SERVICE BULLETIN
Document No. 159-026-00 Rev. 1
Date: August 31, 2009

Subject: Cargo Hook enhanced safety.

Helicopters Affected: All helicopters with an Onboard Systems cargo hook P/N 528-029-00 or 528-029-01 installed. The applicable kit part numbers for these cargo hooks and their approved installations are:

Figure 1 Manual Release Cover Identification

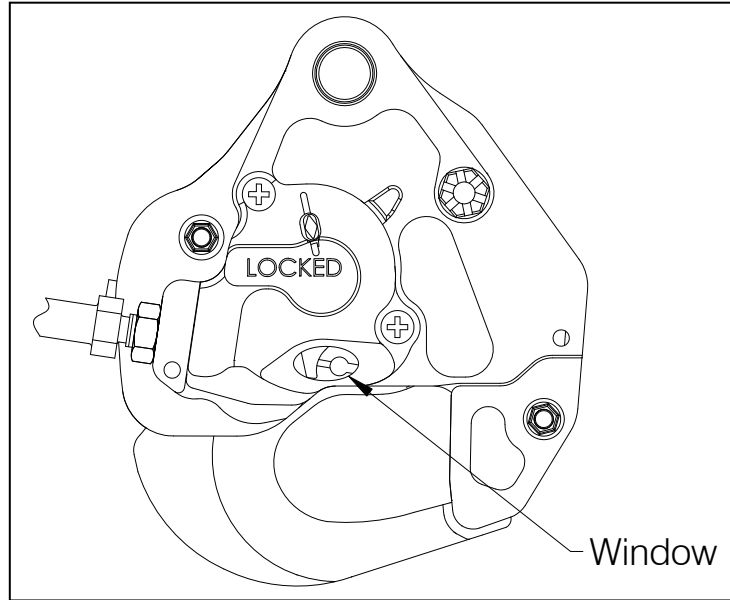
1. Check the cargo hook manual release cover to determine whether this service bulletin has been previously complied with. If the manual release cover has an elliptical window in it, this service bulletin has been complied with. Accomplishment of this bulletin does not affect the part number of the Cargo Hook.

Figure 2 Manual Release Cover Removal

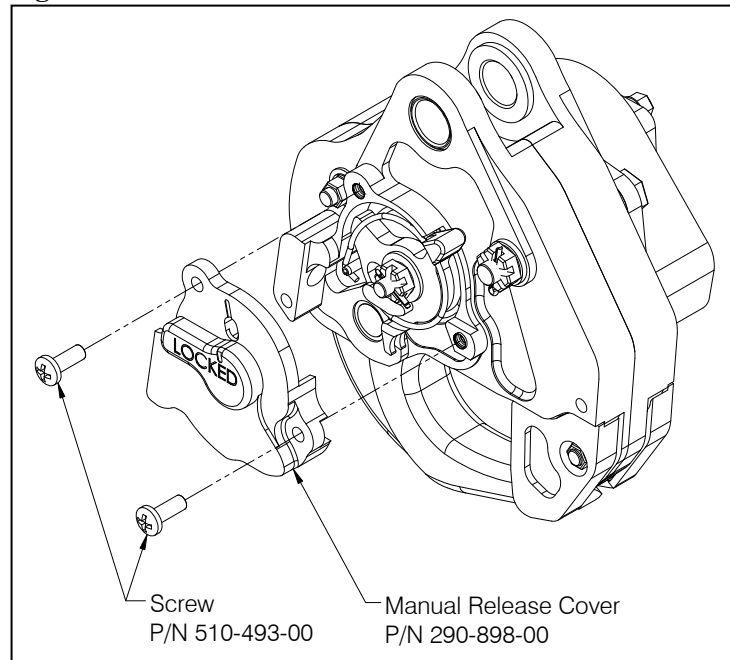
2. Remove existing manual release cover (P/N 290-898-00) by removing two screws (P/N 510-493-00) as shown in Figure 2 below. Retain the screws.

Figure 3 Manual Release Cable Rigging

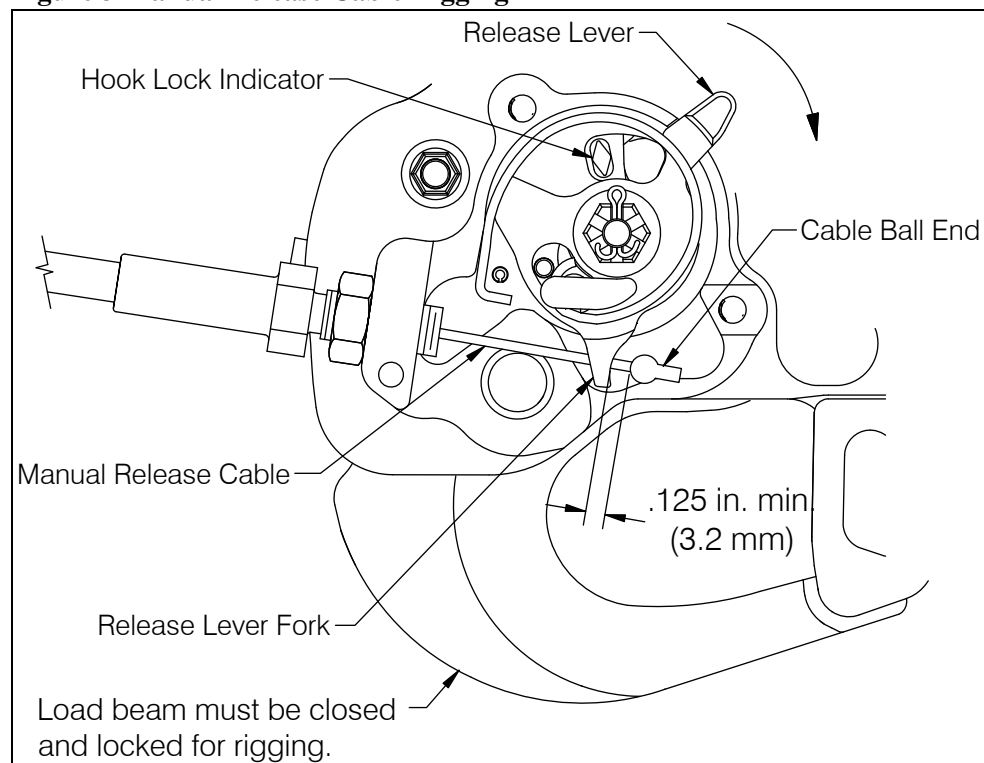
3. Inspect the manual release cable end for frayed wires extending past the cable ball end termination and for kinks or bends. Grind off frayed wires flush to cable ball end, as necessary. Place the cable ball end into the manual release lever fork.
4. Ensure that the manual release cable is rigged properly per the following: Rotate the release lever in the clockwise direction to remove free play (the free play is taken up when the hook lock indicator begins to move, this is also readily felt as the lever rotates relatively easily for several degrees as the free play is taken up) and measure the gap between the release lever fork and cable ball end as shown in Figure 3 with the manual release lever in the cockpit in the non-release position. If necessary, adjust the manual release cable system to obtain a minimum of 1/8 in. (3.2 mm) of gap at the release lever fork.

Manual release cable rigging must be done with the cargo hook in the closed and locked position.

Figure 4 Windowed Manual Release Cover Installation

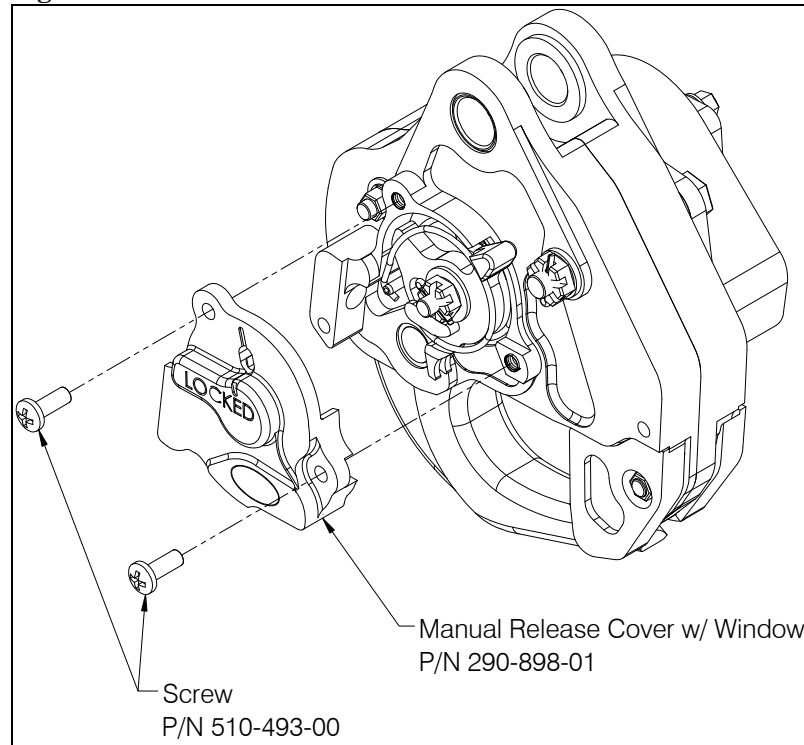
5. Install the new Manual Release Cover with window (P/N 290-898-01) onto the cargo hook with the screws (P/N 510-493-00) that were removed on the previous step.

Figure 5 Hook Locked Indicator

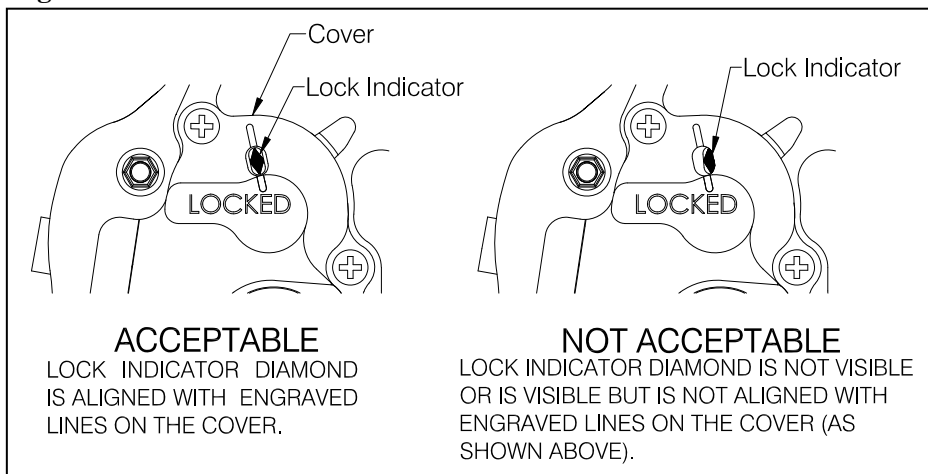
1. Activate the manual release system by pulling the release lever in the cockpit. The cargo hook must release. Reset the cargo hook load beam by hand after release. Verify that the hook locked indicator on the side of the hook returns to the fully locked position. In the fully locked position the hook lock indicator must align with the lines on the manual release cover (see Figure 5).
